dsPIC30F Family Reference Manual Errata Sheet

The dsPIC30F Family Reference Manual (DS70046B) correctly describes the function of the dsPIC30F devices, except for the anomalies described below.

Figure 5-2: NVM Addressing with TBLPAG and NVM Address Registers

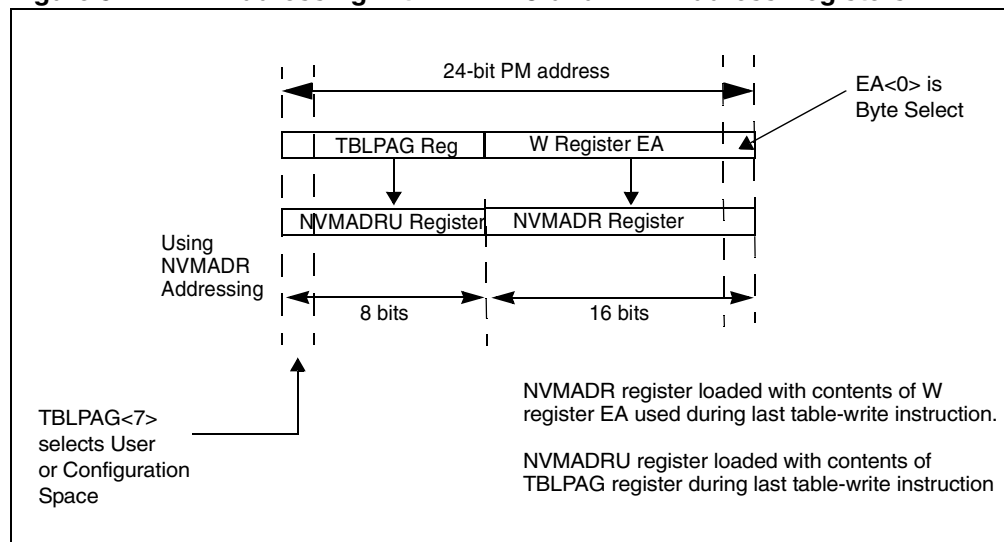
10. Page 5-6, Section 5.3.2 NVMADR Register

On page 5-6, Section 5.3.2 NVMADR Register should be replaced with the following:

5.3.2 NVM Address Registers

There are two NVM Address Registers - NVMADRU and NVMADR. These two registers when concatenated form the 24-bit effective address (EA) of the selected row or word for programming operations. The NVMADRU register is used to hold the upper 8 bits of the EA, while the NVMADR register is used to hold the lower 16 bits of the EA.

The register pair, NVMADRU:NVMADR, capture the EA<23:0> of the last table-write instruction that has been executed and select the row of Flash or EEPROM memory to write/erase. Figure 5-2 shows how the program memory EA is formed for programming and erase operations.

Although the NVMADRU and NVMADR registers are automatically loaded by the table-write instructions, the user can also directly modify their contents before the programming operation begins. A write to these registers will be required prior to an erase operation, because no table-write instructions are required for any erase operation.

Figure 17-21: 10-bit A/D Converter Analog Input Model

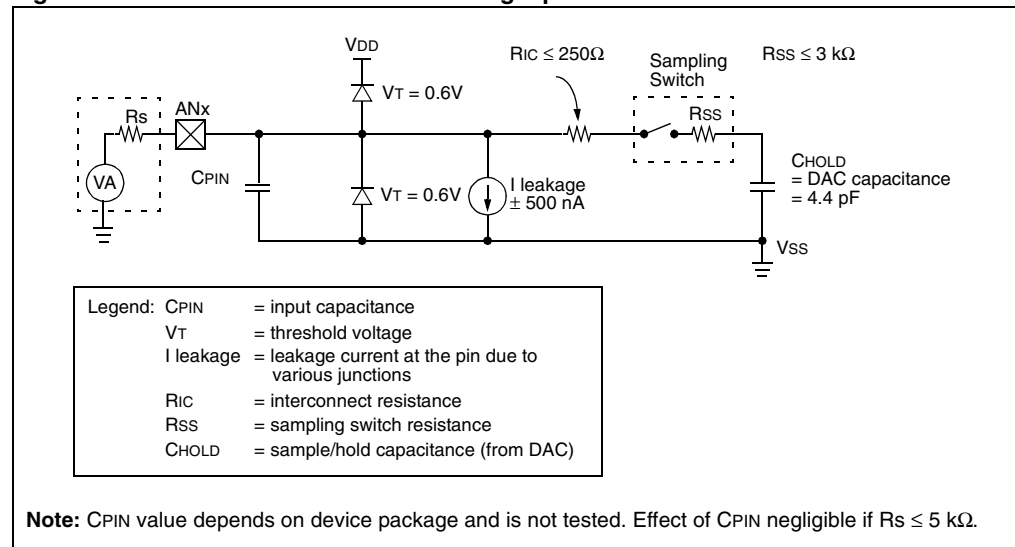
32. Page 17-46, Section 17.16 A/D Sampling Requirements

The entire Section 17.16 should be replaced with the following text and figures:

The analog input model of the 10-bit A/D converter is shown in Figure 17-21. The total sampling time for the A/D is a function of the internal amplifier settling time and the holding capacitor charge time.

For the A/D converter to meet its specified accuracy, the charge holding capacitor (CHOLD) must be allowed to fully charge to the voltage level on the analog input pin. The source impedance (R_s), the interconnect impedance (R_{IC}), and the internal sampling switch (R_{SS}) impedance combine to directly affect the time required to charge the capacitor CHOLD. The combined impedance of the analog sources must therefore be small enough to fully charge the holding capacitor within the chosen sample time. To minimize the effects of pin leakage currents on the accuracy of the A/D converter, the maximum recommended source impedance, R_s , is 5 k Ω . After the analog input channel is selected (changed), this sampling function must be completed prior to starting the conversion. The internal holding capacitor will be in a discharged state prior to each sample operation.

At least 1 TAD time period should be allowed between conversions for the sample time. For more details, see the device electrical specifications.

Figure 18-11: 12-bit A/D Converter Analog Input Model

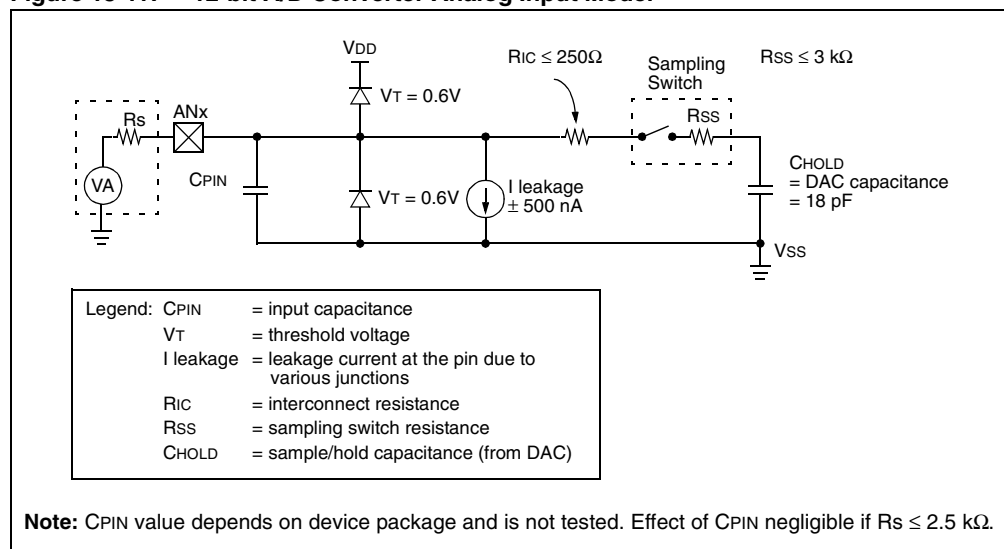
34. Page 18-27, Section 18.15 A/D Sampling Requirements

The entire Section 18.15 should be replaced with the following text and figures:

The analog input model of the 12-bit A/D converter is shown in Figure 18-11. The total sampling time for the A/D is a function of the internal amplifier settling time and the holding capacitor charge time.

For the A/D converter to meet its specified accuracy, the charge holding capacitor (CHOLD) must be allowed to fully charge to the voltage level on the analog input pin. The source impedance (R_s), the interconnect impedance (R_{IC}), and the internal sampling switch (R_{SS}) impedance combine to directly affect the time required to charge the capacitor CHOLD. The combined impedance of the analog sources must therefore be small enough to fully charge the holding capacitor within the chosen sample time. To minimize the effects of pin leakage currents on the accuracy of the A/D converter, the maximum recommended source impedance, R_s , is 2.5 k Ω . After the analog input channel is selected (changed), this sampling function must be completed prior to starting the conversion. The internal holding capacitor will be in a discharged state prior to each sample operation.

At least 1 TAD time period should be allowed between conversions for the sample time. For more details, see the device electrical specifications.
